**SERVICE BULLETIN**

**APPLICABILITY:** 2015 and 2016MY WRX and STI Models

**NUMBER:** 12-201-16R

**SUBJECT:** Paint Chipping between Hood Grille (Scoop) and Hood

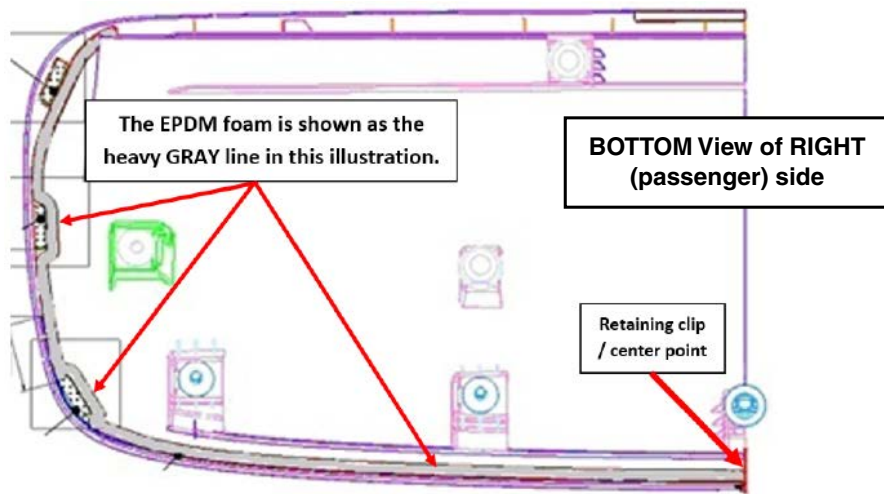
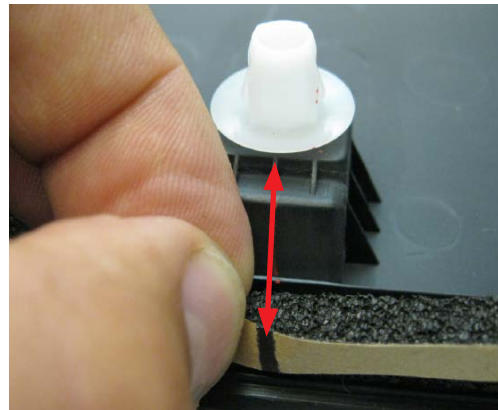
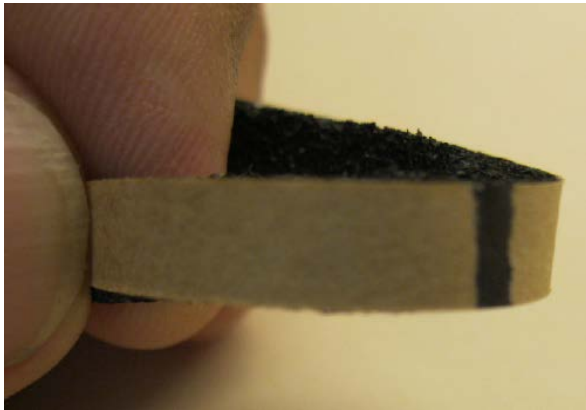
- Using the illustrations below as a guide, clean the areas where the protectors and EPDM foam will be applied with a mild solvent on a clean shop cloth and dry completely. The illustrations and photos below show how the completed installation should appear.

5. Peel the adhesive backing and apply the 6 protectors to the scoop **first**.
6. The piece of EPDM foam tape in the repair kit is 1000 mm long. Locate its center point and put a mark on the adhesive backing. Align the center mark with the white scoop retaining clip as shown below.

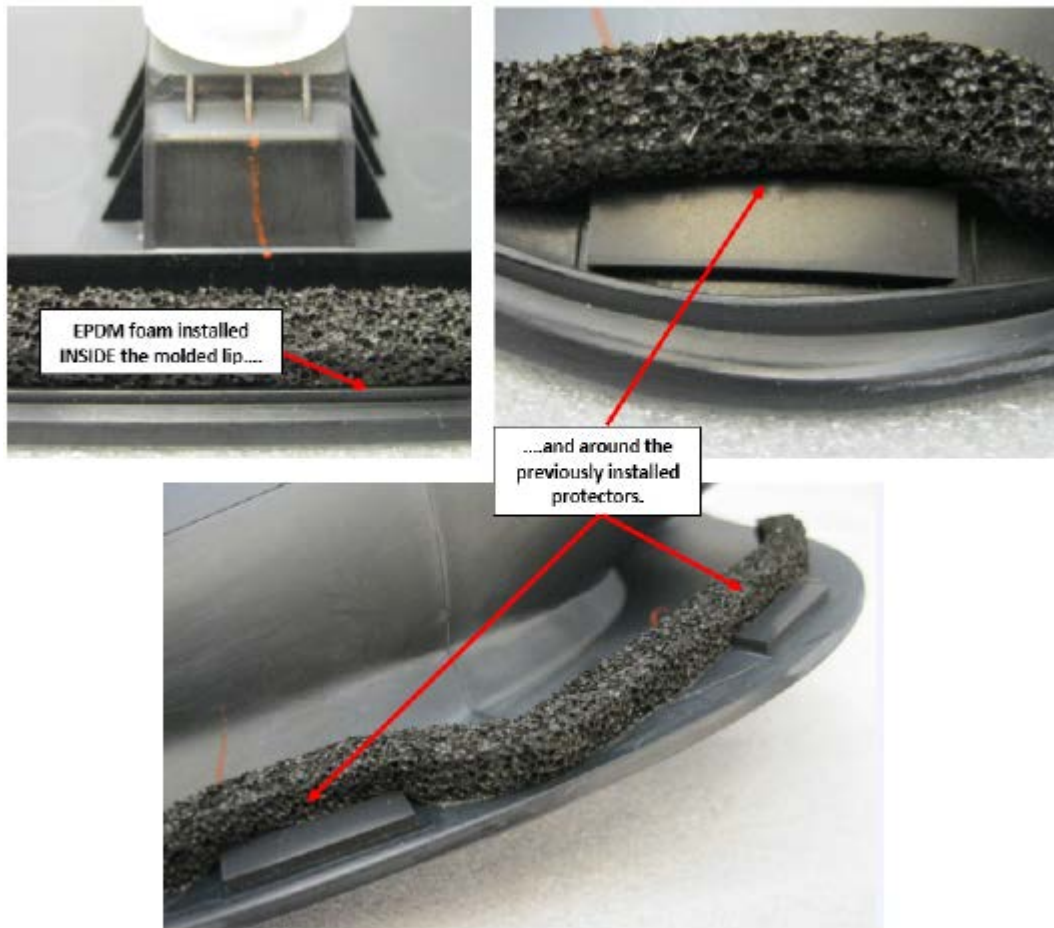
7. **CAREFULLY** peel the backing and working **SLOWLY** outward from the center point, start to apply the EPDM foam **INSIDE** the molded lip along the back edge of the scoop. While being careful not to stretch the foam while applying it, work the foam around the previously installed protectors as shown in the photos below.

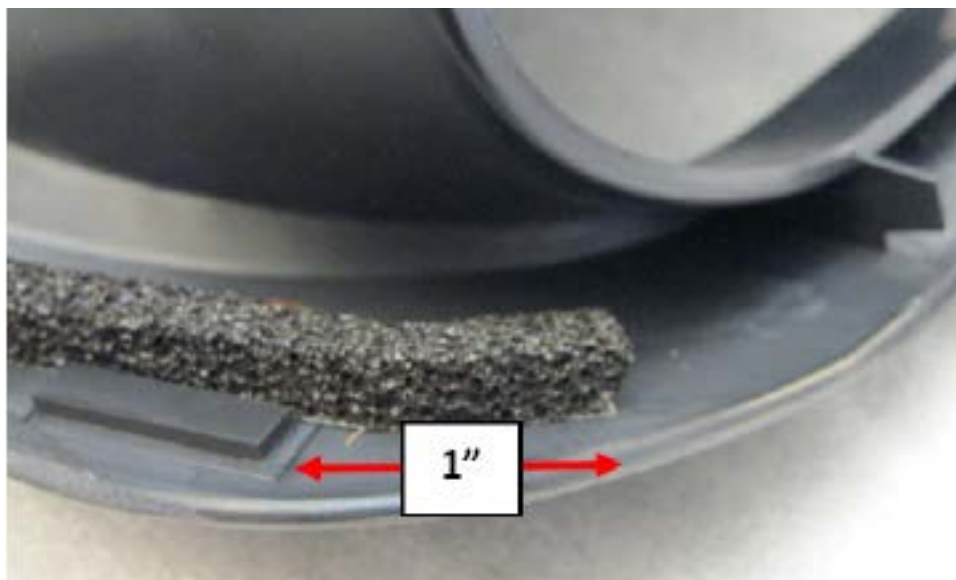
8. When properly installed, the ends of the EPDM foam tape should appear as shown at the rear corners of the scoop, approximately 1" past the edge of the protector (right side shown below).
